EEG-24

POTENTIAL PROBLEMS FROM SHIPMENT OF HIGH-CURIE CONTENT
CONTACT-HANDLED TRANSURANIC (CH-TRU) WASTE TO WIPP

Environmental Evaluation Group
Environmental Improvement Division
Health and Environment Department
State of New Mexico

August 1983

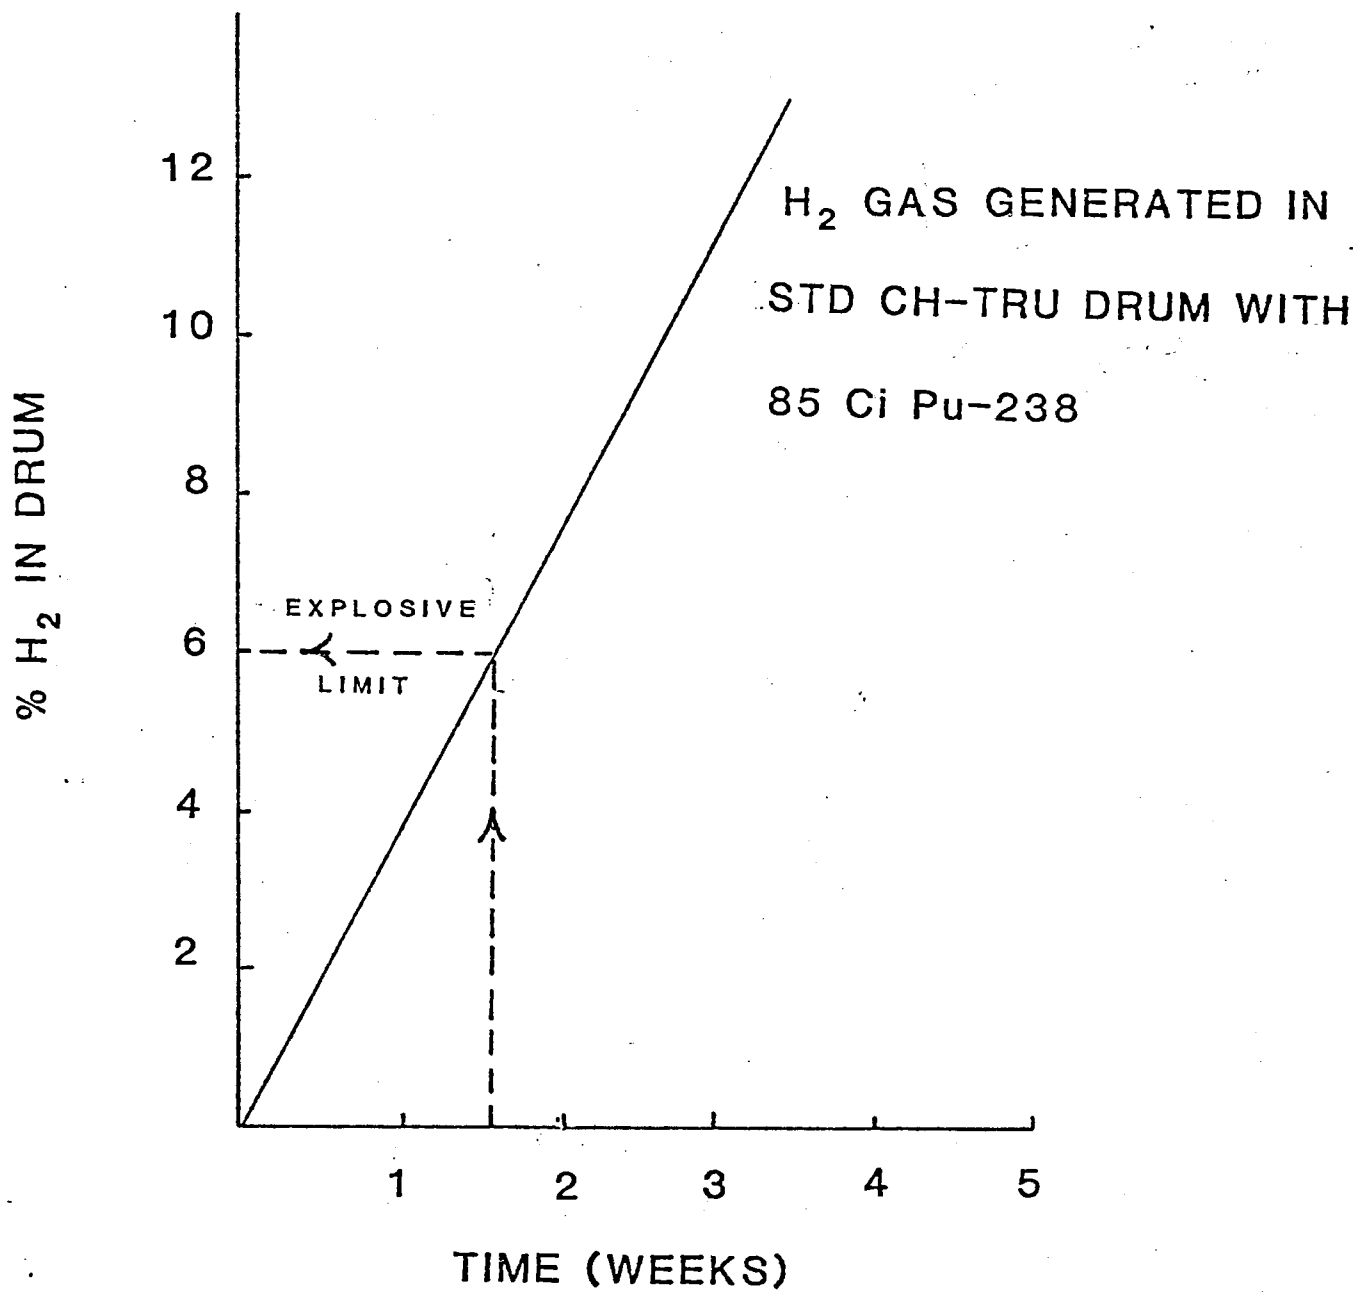
As the following graph shows, a concentration of 6% H_2 could be realized within two weeks if there is no leakage from the drum seals. Data from SRP and LANL indicate that leakage would be expected to occur. According to Zerwekh (Ref. 12), mixtures of 6% or more are explosive. The following calculation indicates the extent. If all 36 drums in a TRUPACT truck shipment had 6% H_2 , it would be equivalent to approximately 0.7 pounds of trinitroglycerol. Blasting operations of rock use approximately one pound of this explosive per cubic yard of rock.
